San Juan Citizens Alliance - Catamount Spring Creek Scoping Comments

Thank you for the opportunity to comment on the proposed Catamount Spring Creek Pipeline and Associated Fruitland Coal Gas Drilling Project. According to the scoping document, the project would permit construction of an 8.4 mile pipeline system for gas and produced water along Spring Creek in the HD Mountains, the expansion of one existing gas wellpad (Pargin Mt UT 2) to facilitate re-completion of one existing gas well, and horizontal drilling of seven new gas wells from the same pad.¹ The pipeline would include an eastward spur connected to the Fed 26-1 wellpad, which contains one existing well drilled in 1999 that is not in production. Catamount has filed an APD for new horizontal wells to be drilled from that pad. The project is tiered to the 2013 San Juan National Forest Land and Resource Management Plan (LRMP)² and the Northern San Juan Basin Coal Bed Methane Project EIS (NSJB EIS).³ These overarching plans govern, and detail best management practices (BMPs) for oil and gas projects in the Northern San Juan Basin. At the state level, CPW provides recommended oil and gas stipulations for certain species and

Fig 1. Domestic and household use wells within the 1,000 horizontal foot buffer to the pipeline

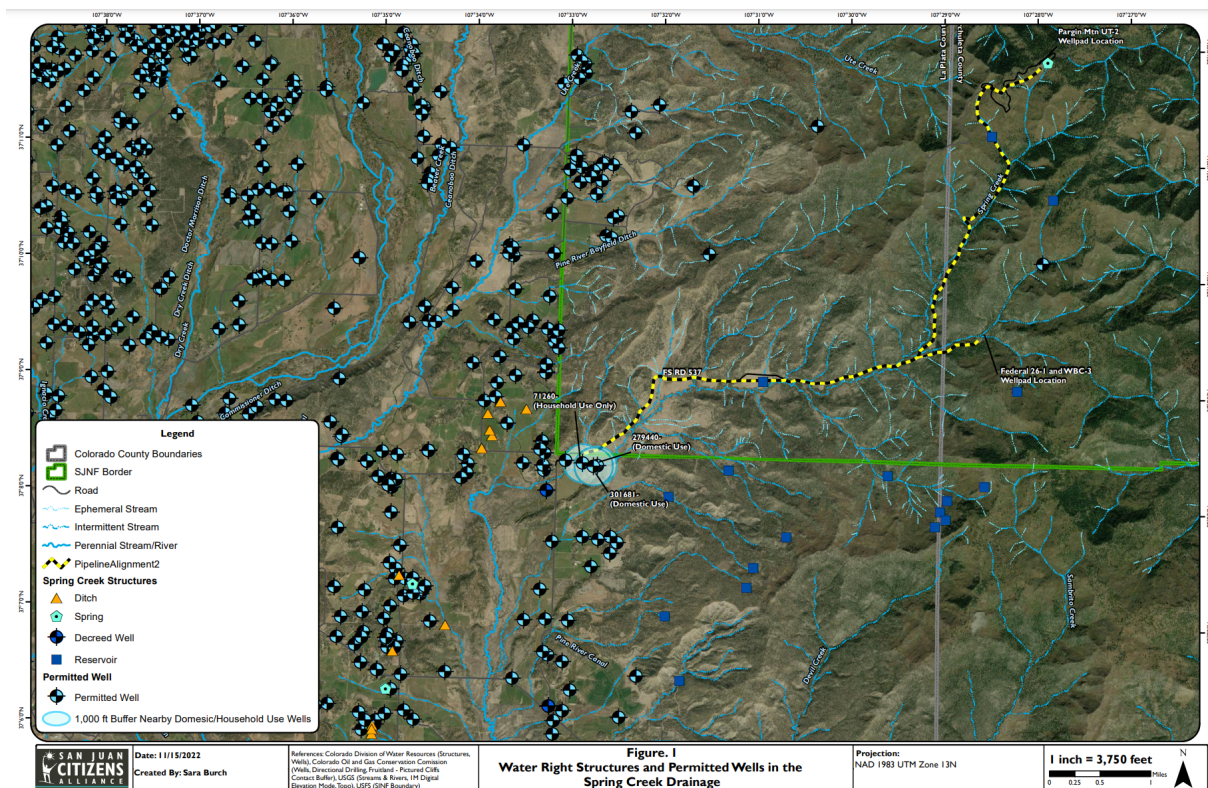
Spring Creek is the source for various water rights structures near the proposed pipeline. Downstream of the project area, Spring Creek confluences with the Los Pinos River, which provides domestic and household water for the town of Ignacio and households throughout Southern Ute Tribal Lands. The NJSB EIS states “For all domestic water supplies using a groundwater well or spring, no surface occupancy would be allowed within a minimum distance of 1,000 horizontal feet.” Spatial analysis of permitted wells nearby the proposed pipeline suggest two domestic wells are located within a 1,000 horizontal foot buffer to the pipeline, as well as one permitted well for household use.

Fig 2. Pipeline ROW intersects WIZ and Riparian buffer, and/or slopes > 35%

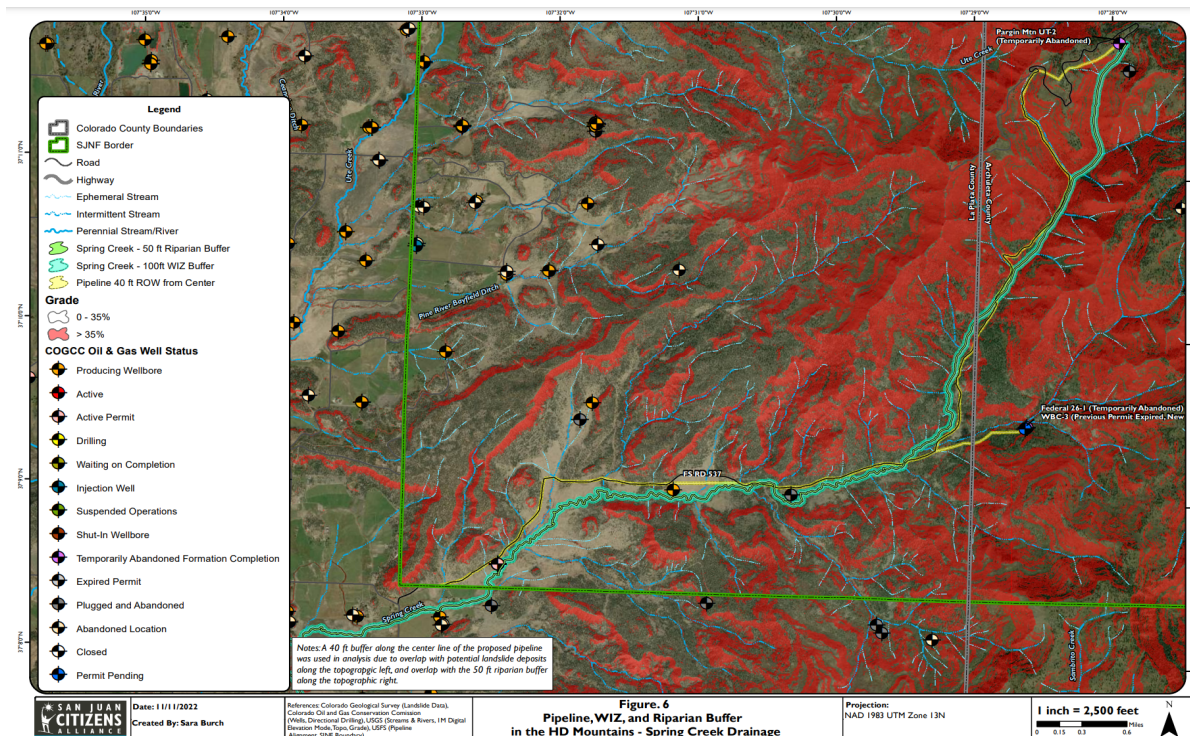
The existing access road to Pargin Mt UT 2 and the pipeline paralleling it are well within both the WIZ and the riparian buffer as illustrated in the figure below. According to the Scoping Document, a 40 foot right of way (ROW) would be implemented along the pipeline alignment. There are concerns with the alignment of the ROW, as a topographic left-alignment would situate the pipeline and the ROW within slopes exceeding 35% grade, and within landslide deposits. A topographic right alignment or central alignment would situate the pipeline and its ROW within the 100 foot WIZ buffer and 50 foot riparian buffer along Spring Creek.

Fig 3. Development in Elk Severe Winter Range and Winter Concentration Areas

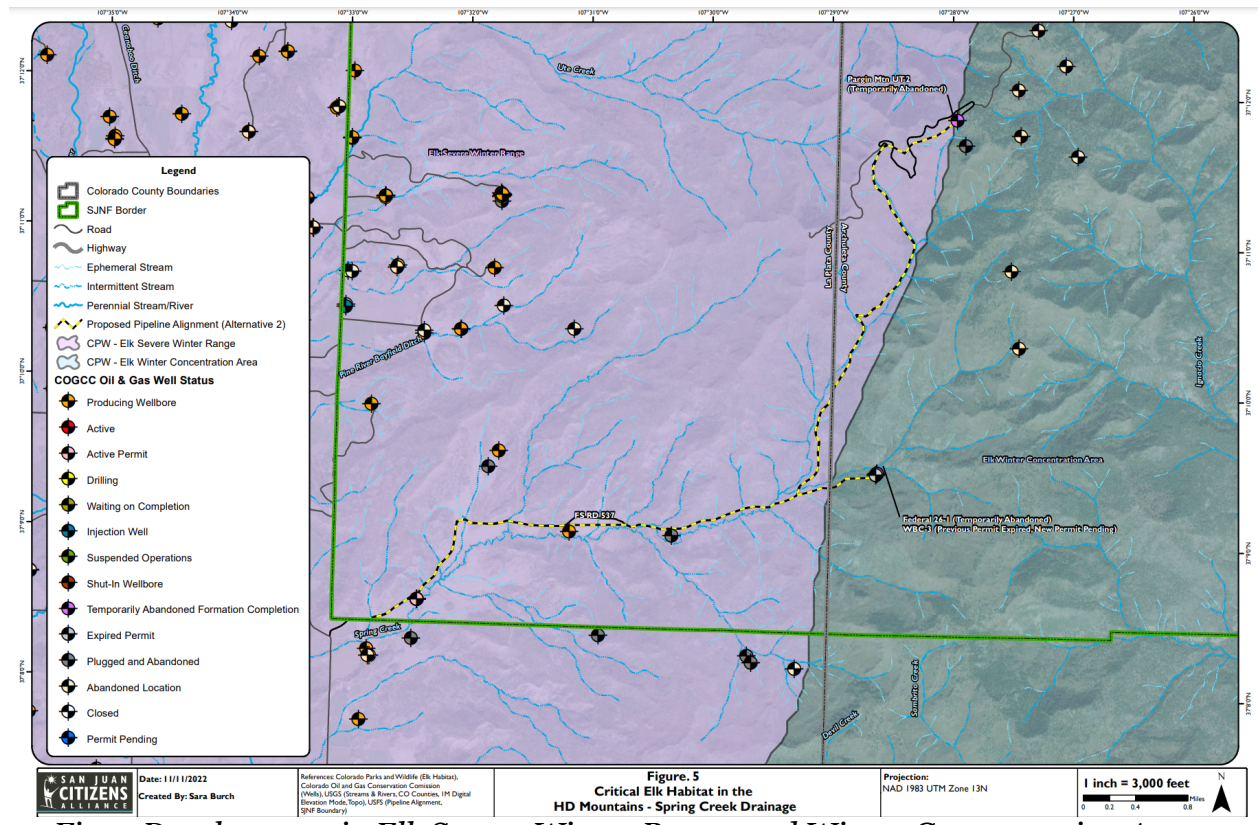
In these areas, CPW recommends that Timing Limitation Stipulations (TLS) be attached to oil and gas development prohibiting human activities between December 1 and April 30, and recommends stipulations limiting surface disturbance to one wellpad per square mile.⁷ We share CPW’s concerns with potential impacts to our already over-pressured ungulate populations and their habitat.

Fig 4. Pipeline alignment in steep slopes and through landslide deposits

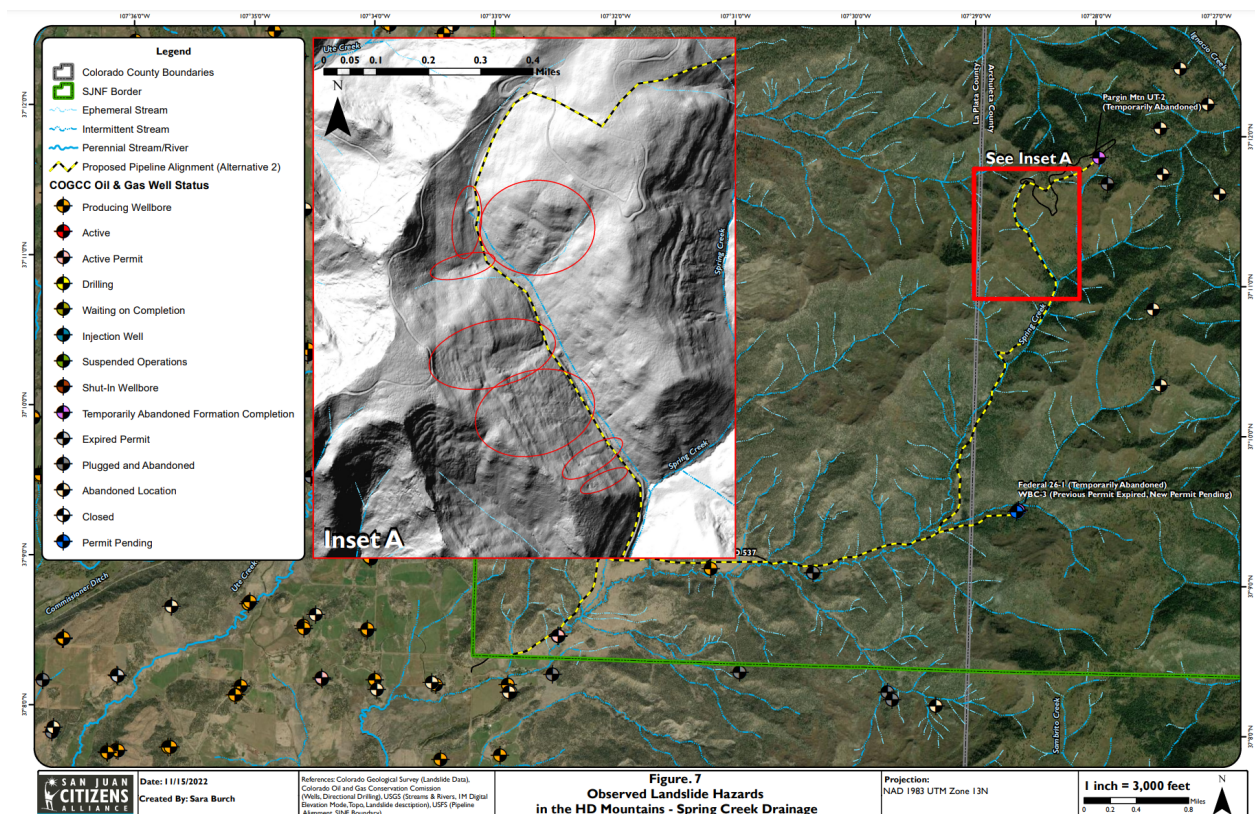
The LRMP establishes NSO stipulations on lands prone to mass movement, and a 100 foot NSO buffer around those lands.¹³ “Lands with slopes greater than 35%” are explicitly included in the plan’s definition of “land prone to mass movement” along with lands that display evidence of past movement, including landslides. Topographic analysis identified several portions of steep slopes adjacent to Forest Road 537 with evidence of landslide activity, particularly along the road segment that deviates from Spring Creek and continues along an ephemeral drainage before traversing east to Federal 26-1. We are concerned with the alignment of the proposed pipeline that would cross several landslide deposits throughout this portion of the project area (See Figure 4).

Fig 5. Road grade often exceeds permissible slope angle

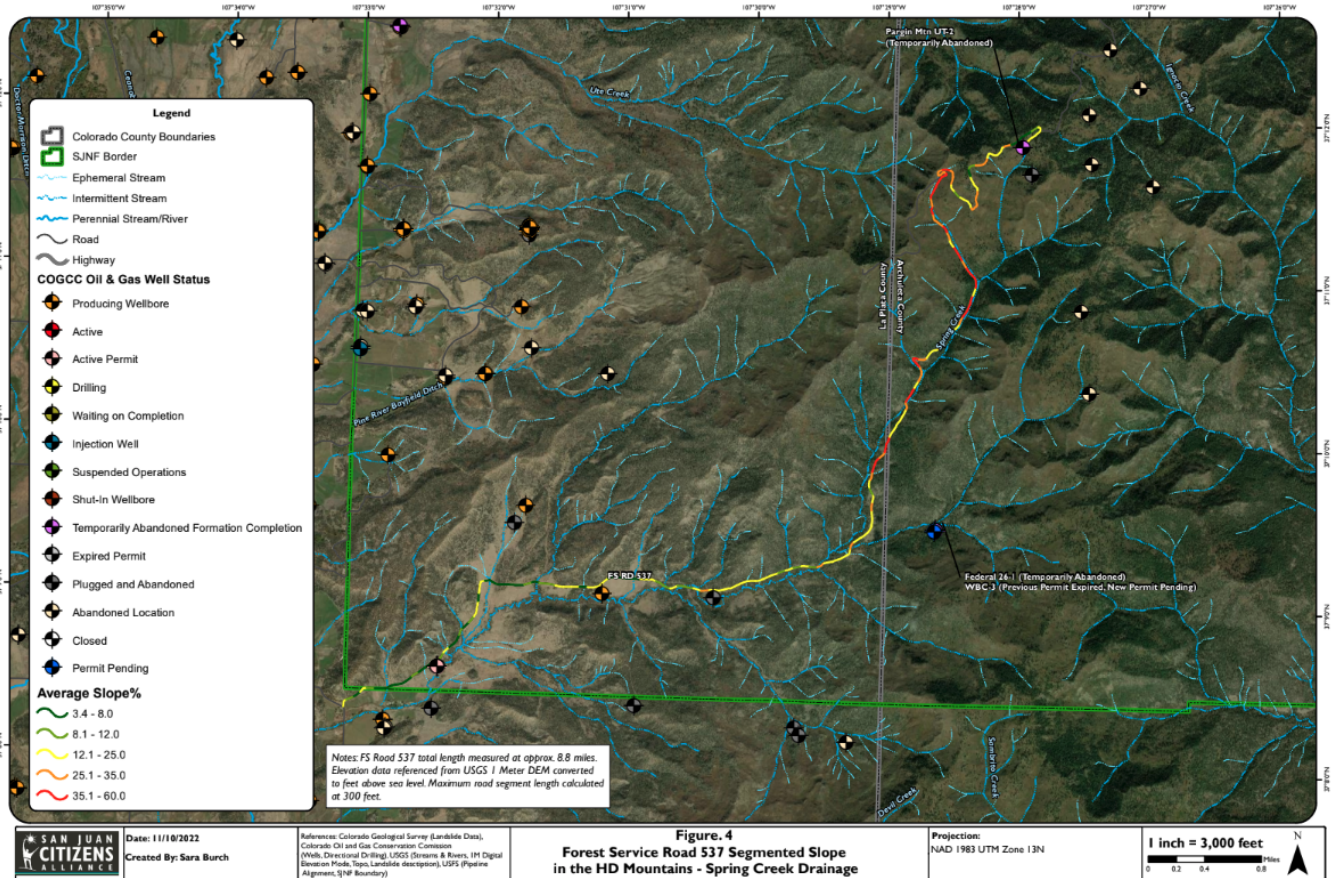
Additionally, the access road itself often exceeds 12%, at times exceeding 35%, in violation of BMPs outlined in the NSJB EIS (See Figure 5). That document requires that “Maximum road grades are 8 percent, except for short pitches up to 12 percent for 300 feet or less.”¹⁴ The EIS directs the Forest Service to “Consider steeper grades in those situations where they result in lesser environmental impact.” We find that position difficult to defend given the loose soils and demonstrable landslide risk in the project area.

- 14.4 % (approx 1.3 miles) of road is >35% slope
- 17.5% (approx. 1.5 miles) of road is between 25.1%-35% slope
- 38.2% (approx 3.4 miles) of road is between 12.1%-25% slope
- 11.8% (approx 1 mile) of road is between 8.1%-12% slope
- 18.1% (approx 1.6 miles) of road is between 0%-8% slope

Fig 6. Existing wells and bores

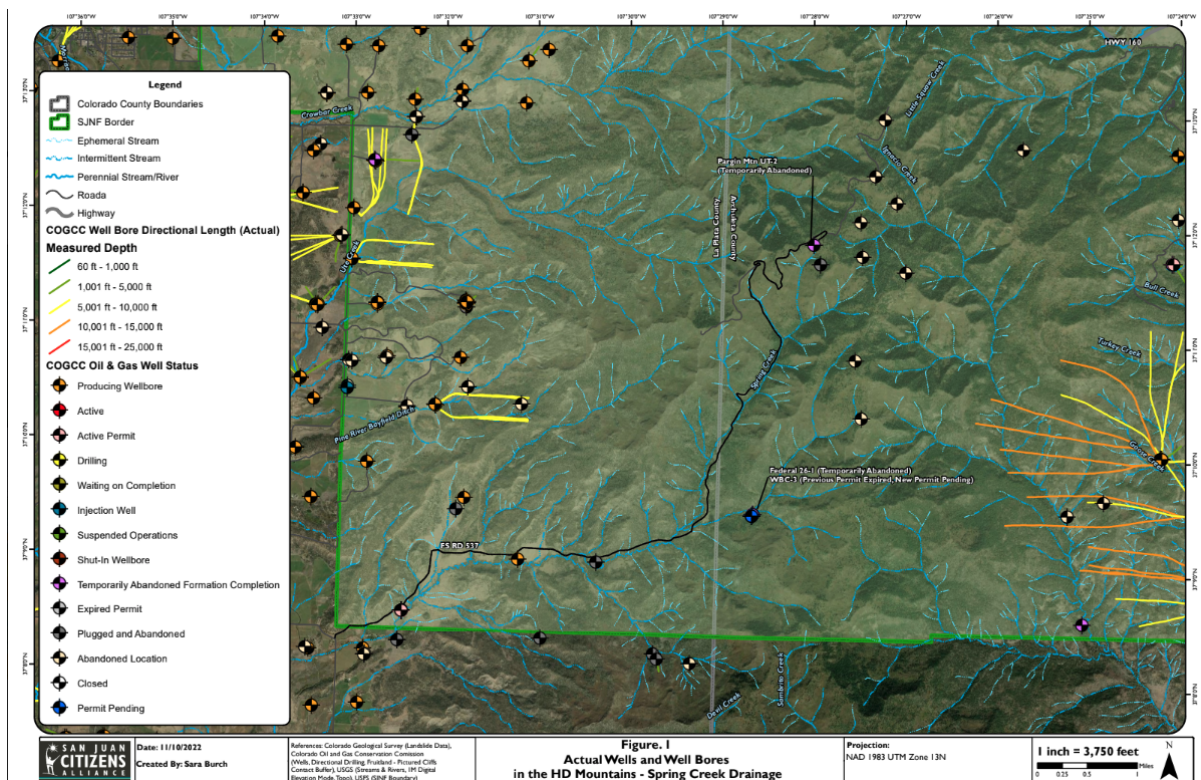
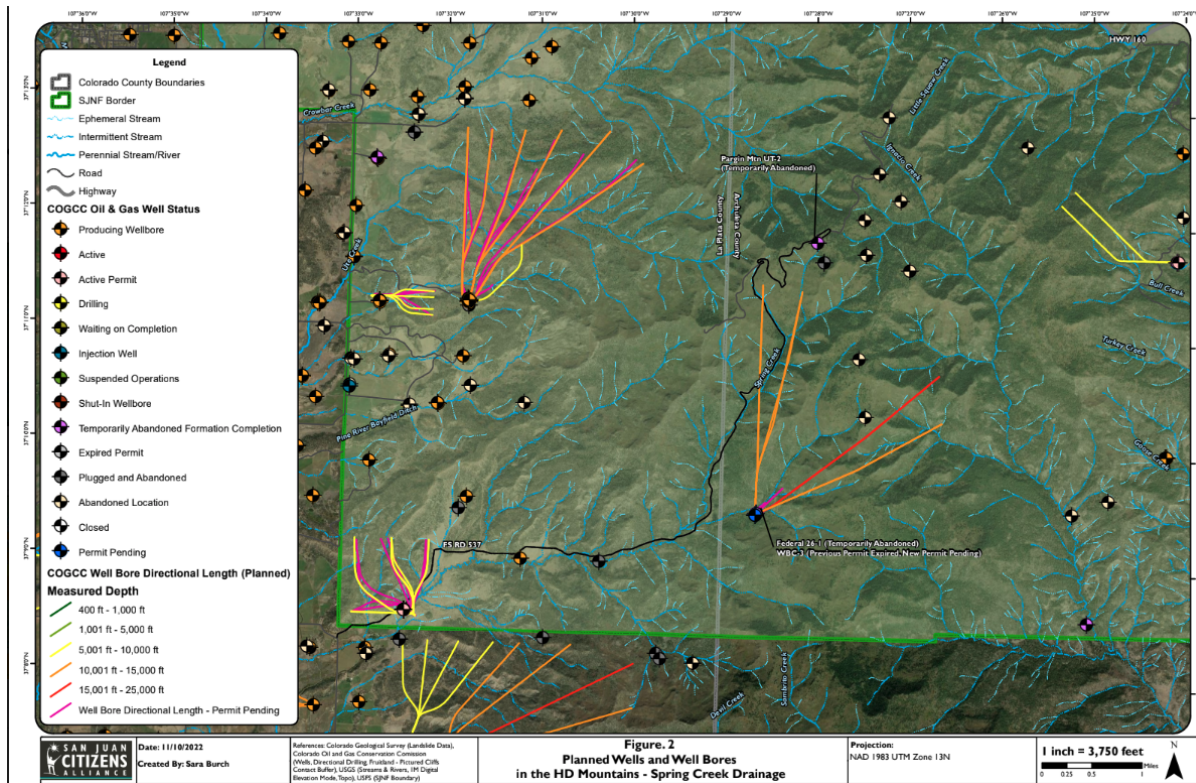
These actions must also be reviewed in the context of their cumulative impacts. Please review the scale of existing and reasonably foreseeable cumulative impacts from nearby oil and gas projects including existing horizontal wells in Salt Creek, existing wells in Goose Creek, proposed wells in Bull Creek, and the cumulative potential impacts of subsidence and seismic activity from oil and gas development in the HDs. Please also consider noise impacts in this cumulative review, as our members have complained about noise mitigation issues with Catamount wells in Goose Creek.
